Service Bulletin

S.B. No: 188

Title: INSPECTION FOR RUDDER PEDAL CLEARANCES BETWEEN RUDDER PEDALS AND THE AIRCRAFT STRUCTURE AND COMPONENTS

Applicability: T67B, T67C series, T67M, T67M-MkII and T67M200 (excluding works no. 2264 & 2265).

FIGURE 1

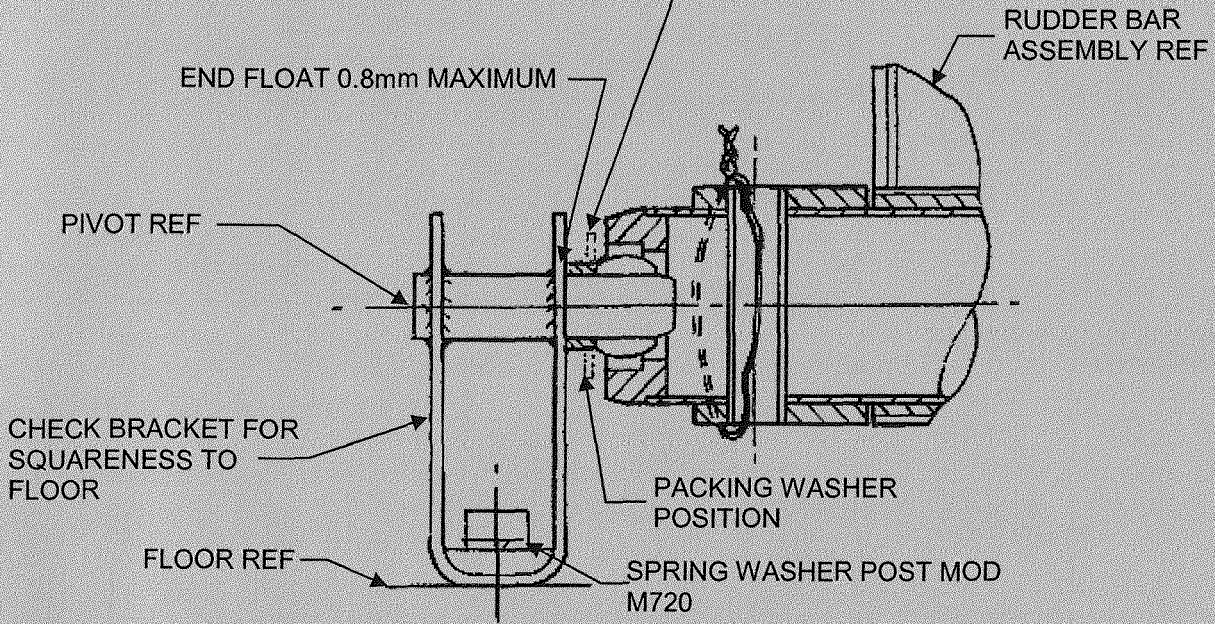
3. Check rudder pedal bar end float is no greater than 0.8mm. If it is greater than 0.8mm then rectify end float IAW paragraph 8. Refer Figure 1.
4. Check that the Rudder Pedal bar port outboard support bracket, ref. Figure 3, is square to the floor and not "lozenged" and there is no deformation to its base. Check floor panel under area of bracket, inspect for cracking which could allow the bracket to lean. If necessary remove floor panel and check for signs of cracking in the floor around the anchor nuts on Pre Mod M919 aircraft or the anchor nut mounting plate Post Mod M919 aircraft, refer Figure 2. Any GRP damage will be shown as a white shadow on the GRP, with cracking felt as a rough edge. A light shining up through the floor will show a shadow.

8. Referring to Figure 1 ensure at each rudder bar pivot position that there is one spacer T67M-45-507 OR one off washer 126-23-748 and up to a maximum of two off washers 126-23-749, i.e. 3 washers maximum.

If end float greater than 0.8mm, then 1 off packing washer may be added at each pivot position as required, i.e. 126-23-105 washer or 126-23-748 washer or 126-23-749 washer.

If packing washers are required on the right hand rudder bar (T67M-45-259), then the packing washer, (or the thicker washer if a thick and thin washer are required) should be placed at the outboard pivot. When end float of 0.8mm maximum achieved ensure that the brake cylinders are not subject to undue side load. If in doubt contact SACL

Note; it is imperative that the combination of packing washers is adhered to as any more than the stated amount may allow the rudder bar mounting brackets pivots to become out of safety.

SPACER T67M-45-507 OR 1 OFF WASHER 126-23-748 PLUS 1 OR 2 OFF 126-23-749 WASHERS MUST BE FITTED

FIGURE 2

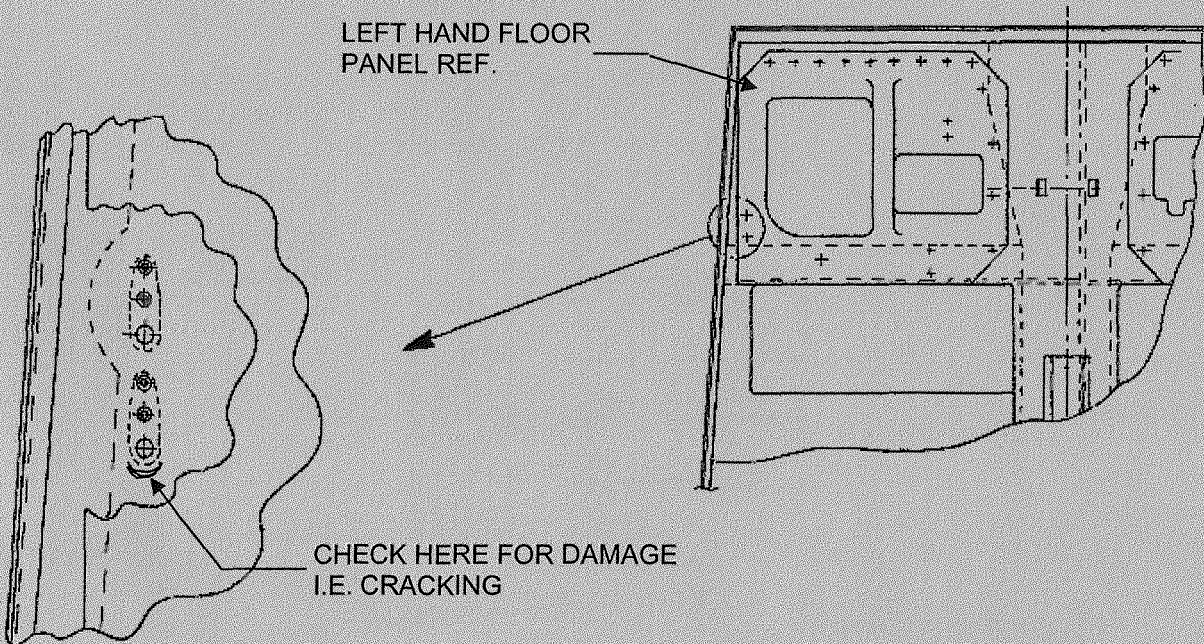
5. If floor is found to be cracked or broken then repair IAW DOI T67C-149 incorporating Mod M919. If Mod M919 has been previously incorporated and floor is damaged inform SACL.

FIGURE 3

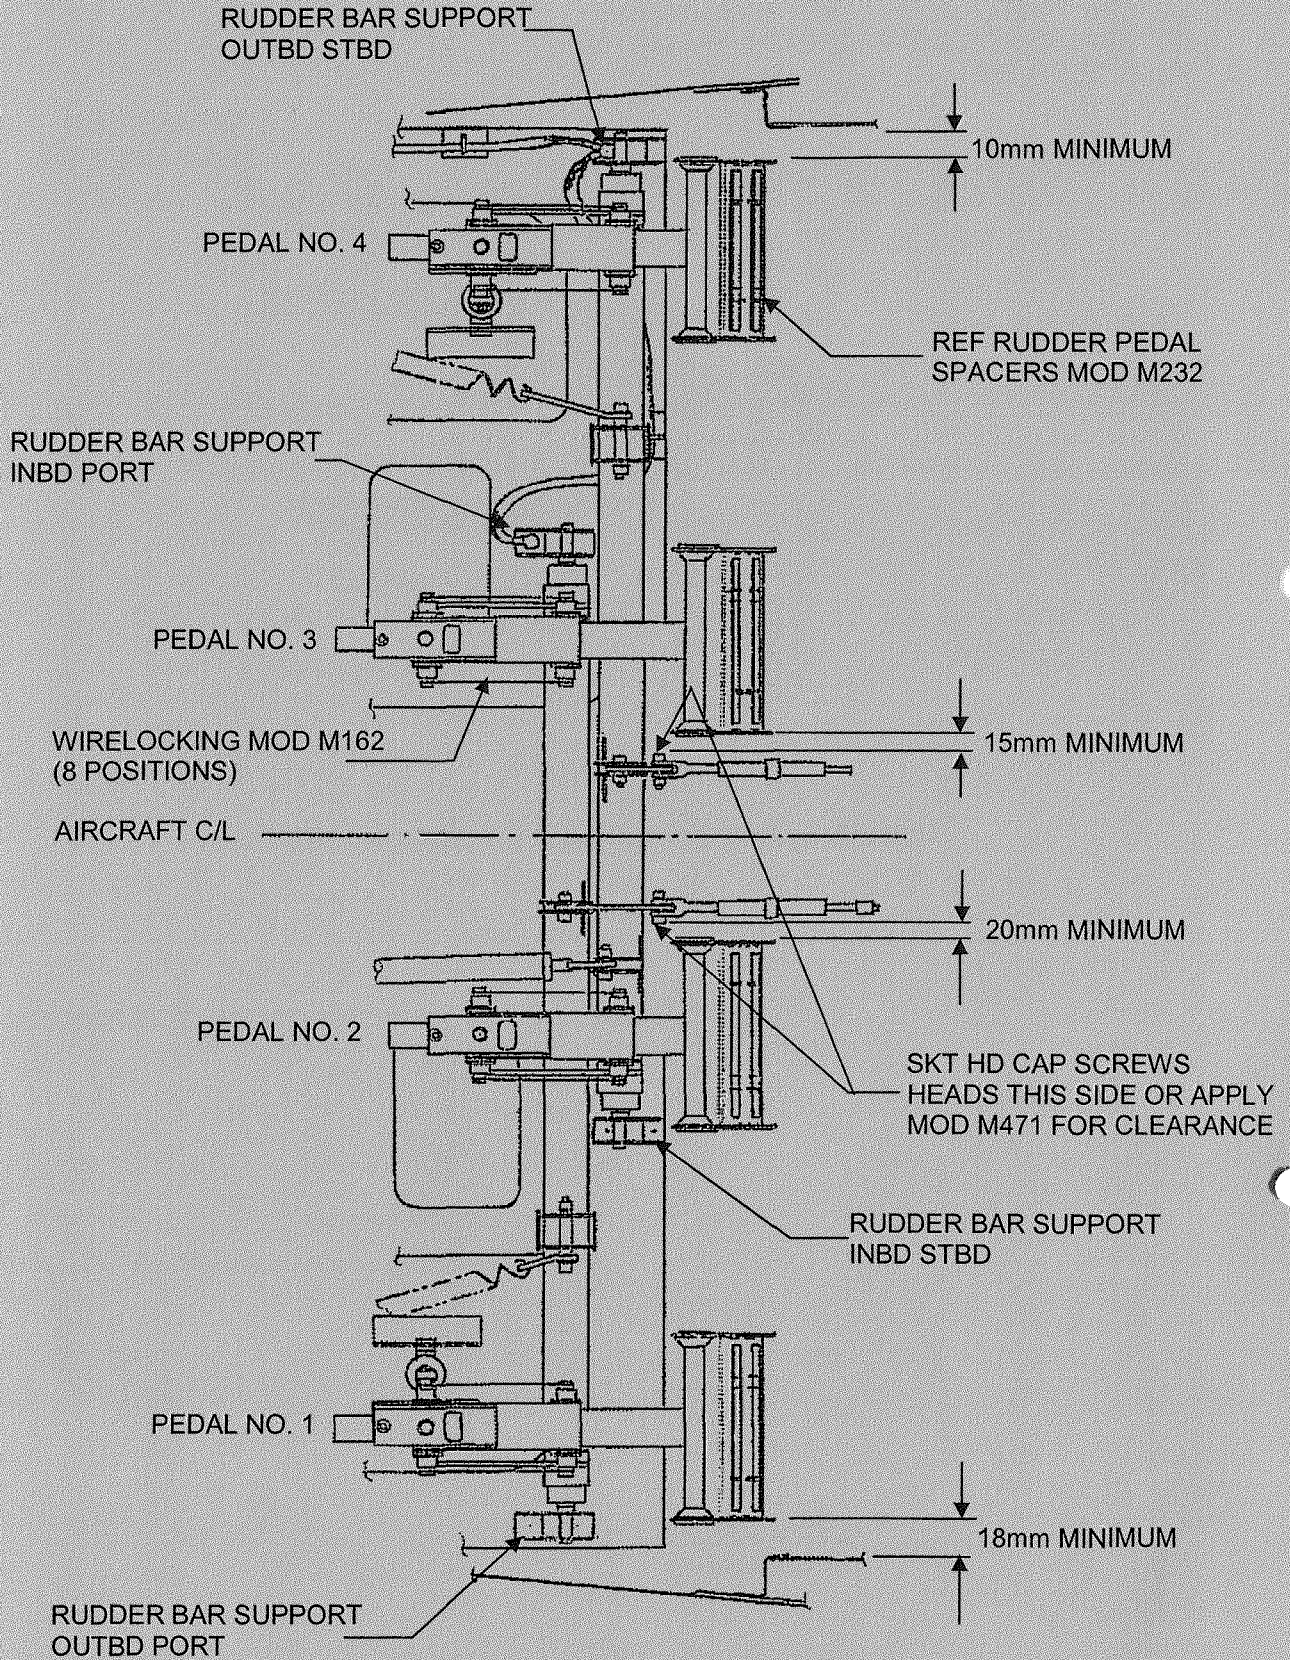
7. Check the remaining rudder bar support brackets, ref. Figure 3, are square to floor and not "lozenged" and there is no deformation to their bases. If any bracket is found to be suspect replace with new item. Inform SACL of any damaged bracket. Assemble item as per paragraph 6 and ensure end float is as stated in paragraph 8. Ensure bonding leads are correctly fitted, carry out bonding check refer relevant aircraft's Maintenance Manual.

11. Ensure Trim Panel Modification M992 "Introduction of Fasteners to Front of Frame 2 to 3 Trim Panel for Added Security" has been incorporated.
12. Upon completion of rudder movement set-up ref. Paragraph 10 above. Ensure minimum clearances of trim panel to pedal side plates and rudder cable to pedal side plates are met Figure 3 refers. If necessary to obtain the required clearances, Mod M232 "Introduction of Rudder Pedal Packing for Increased Clearance of Surrounding Components" may be required to be invoked. Refer paragraph 7 for packing washers.

14. Ensure head orientation of rudder cable link bolt head is outboard, Figure 3 refers, this is a Low Pan Head bolt T67M-45-570 on Post Mod M471 "Introduction of Pan Headed Bolt on Rudder Cable Turnbuckles", aircraft.

16. Ensure the requirements of, SB 99 "Inspection and Rectification of Rudder Pedal Sliders", has been achieved.
17. Ensure rudder pedal carriage socket head caps screws are wire locked and bonded in with adhesive 126-51-024, use minimum amount, Mod M162 "Wire Locking of Rudder Pedals – Upper Pivots", refers. See Figure 3.

FIGURE 4

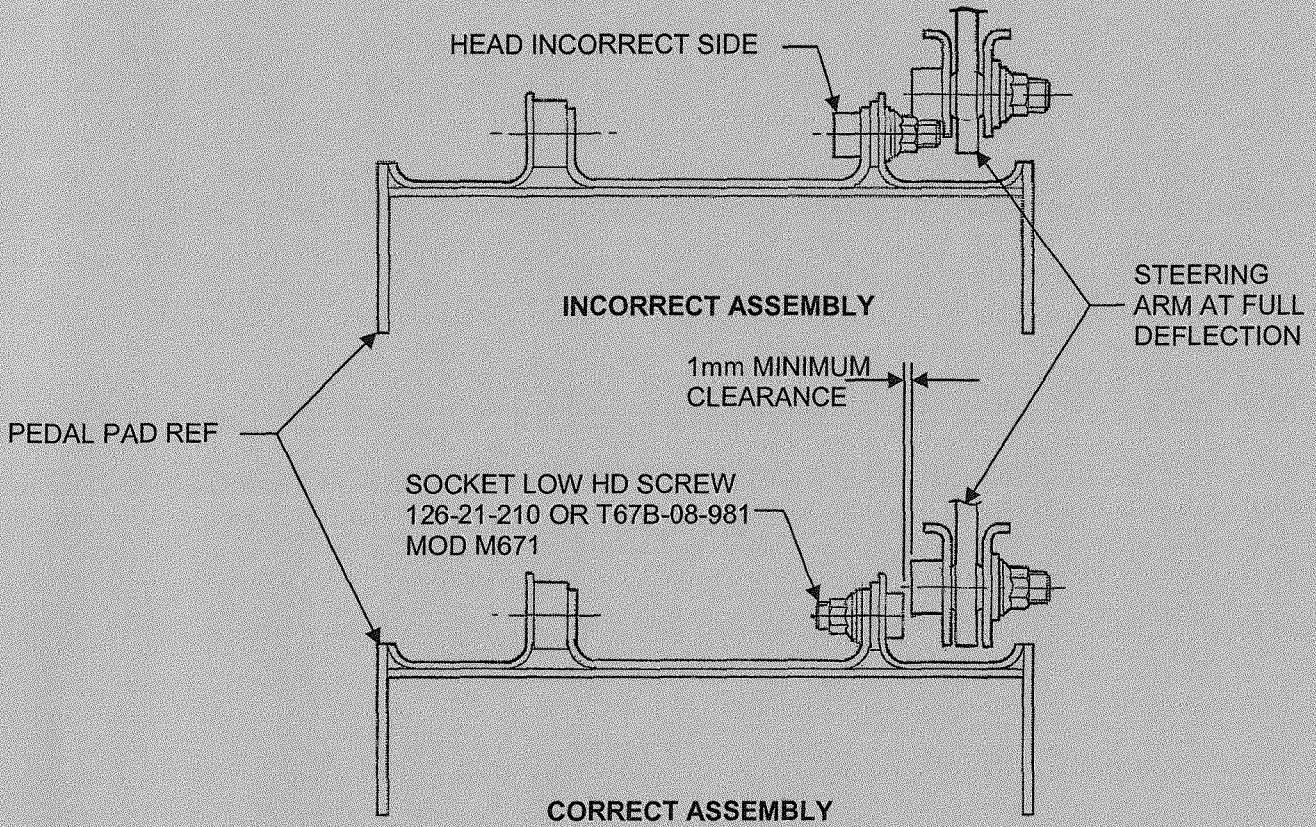
15. Ensure Pedal no 2 Pedal pad pivot bolt head height is less than 5mm and orientated as shown in Figure 4. A minimum of 1mm clearance is required, if not fit part no 126-21-210 or T67B-08-981, this invokes Mod M671 "Introduction of Low Head Rudder Pedal Pad Pivot Bolts – Pedal No. 2".

FIGURE 5

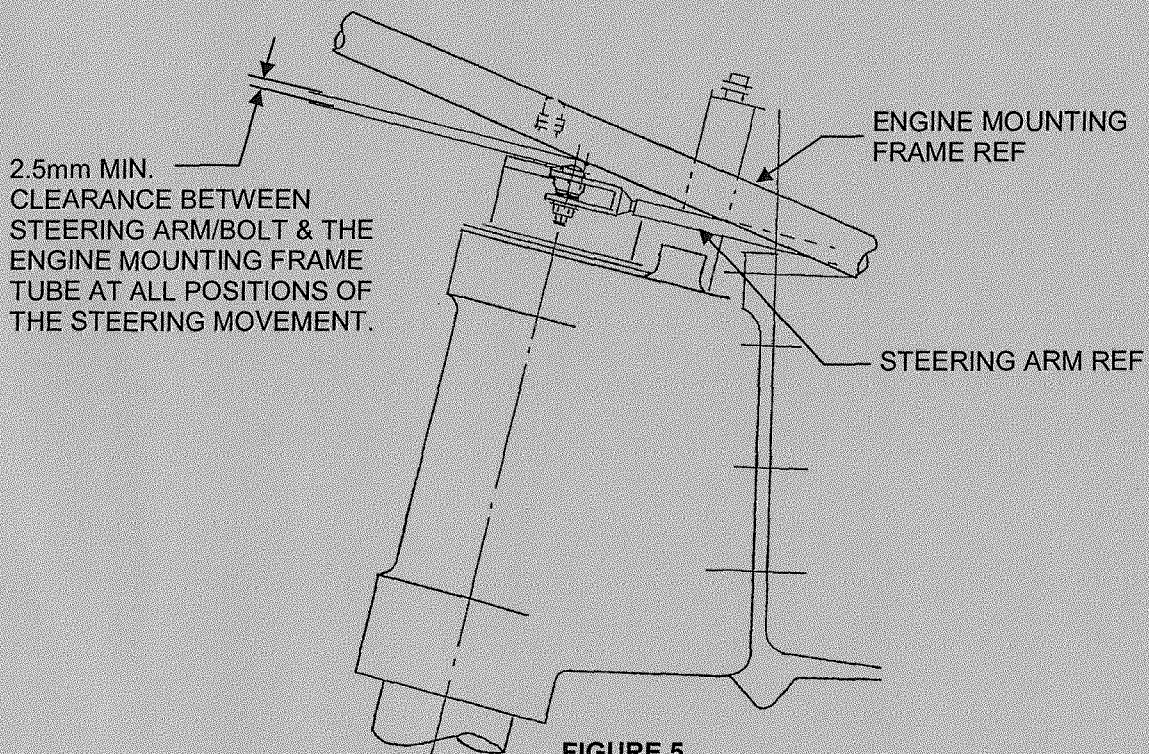
18. Ensure on aircraft fitted with the Fairey Hydraulic undercarriage, (Post Mod M468 or Mod M791), that there is a minimum clearance of 2.5mm with steering linkage to engine mounting frame, see Figure 5. Ensure there is no damage to engine mounting frame if clearance is less than 2.5mm. If engine mounting frame is damaged then aircraft must not be flown until damage is rectified, consult SACL. Also if clearance is less than 2.5mm embody Mod M575 "Introduction of Offset Steering Arm Pin – Ref Fairey Hydraulics Nose U/C", if Mod M575 is fitted and clearance is less than 2.5mm inform SACL.
